LOCKHEED AIRCRAFT CORP.		ENGINEERING STUDY <input type="checkbox"/>		CHANGE PROPOSAL <input checked="" type="checkbox"/>		LAC -93-1*				
DATE 6-6-61		AFFECTS : WSPO <input checked="" type="checkbox"/>		PROJECT <input type="checkbox"/>						
NAME OF MAJOR COMPONENT		PART OR LOWEST SUBASSEMBLY		PART NO. & MODEL OR TYPE						
TITLE OF PROPOSAL : OXYGEN SYSTEM IMPROVEMENTS										
NATURE OF PROPOSAL : SEE PAGE 2 *(Revised to include aircraft 388/721 and 394/954 - see Item 4.)										
REASON FOR PROPOSAL : To incorporate supplemental safety provisions in the ships oxygen system to reduce fire hazard without detriment to existing efficiency. Proposed improvement include: 1. Use of slow opening manual control valves in place of present automatic opening connectors and the on-off feature of the pressure reducers to eliminate high pressure surges and resulting adiabatic heating. 2. Removing the cockpit low pressure gage to prevent possible misinterpretation of indicated pressures. 3. Relocating the modified pressure reducers and (improved) relief valves from the cockpit to the Q-bay within a box for protection against grease and dirt. Except for the high pressure gage, only low pressure

FIGURE 2.

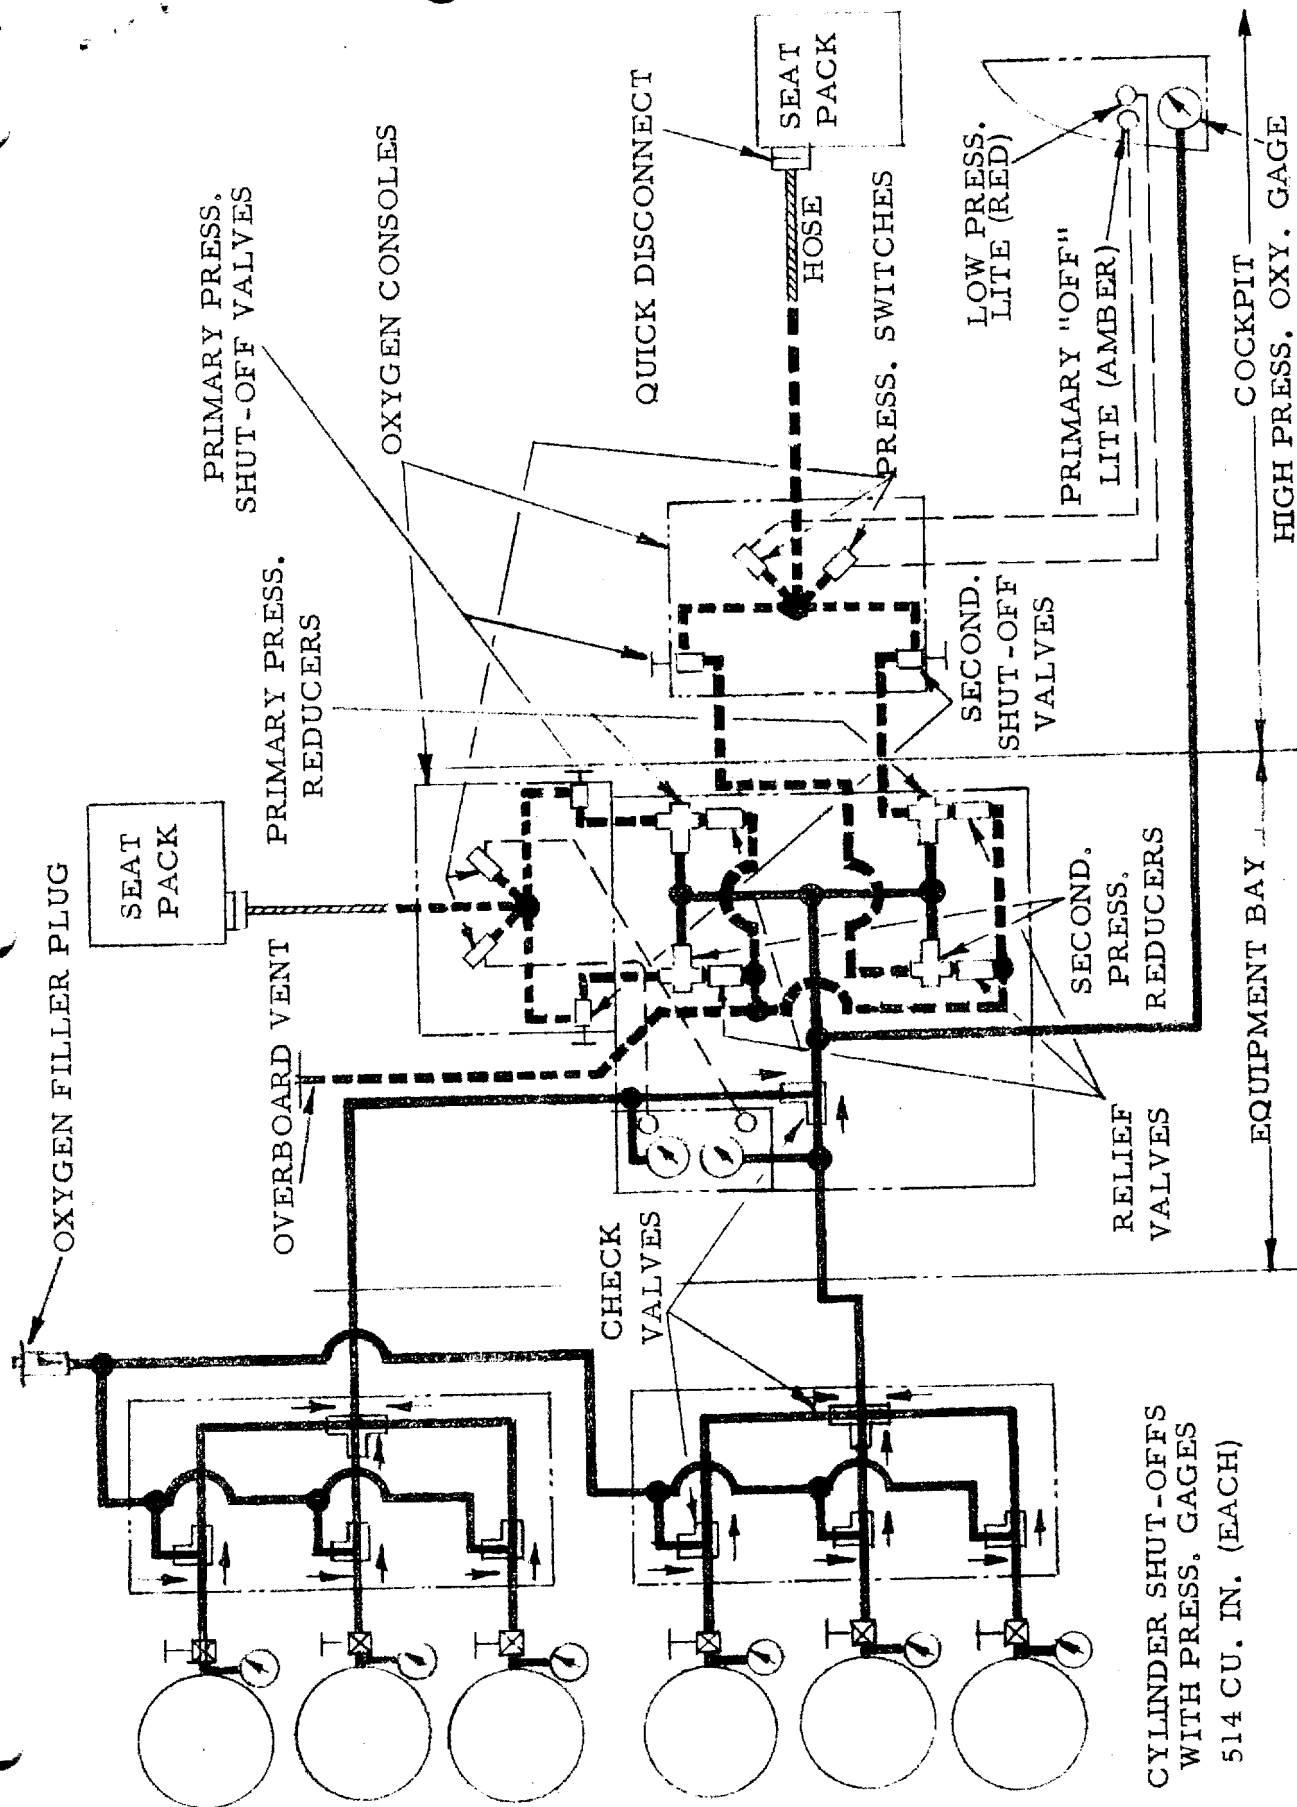
2. Prepare and issue a Service Bulletin.
3. Fabricate appropriate aircraft provisioning kits.
- *4. Modify aircraft 388/721 and 394/954 as follows:
 - a. Cockpit - Same as Item 1.a. except see Figure 2.
 - b. Q-Bay - Install improved relief valve and rework pressure reducers for both pilot and equipment operator in existing equipment operators left-hand side console.
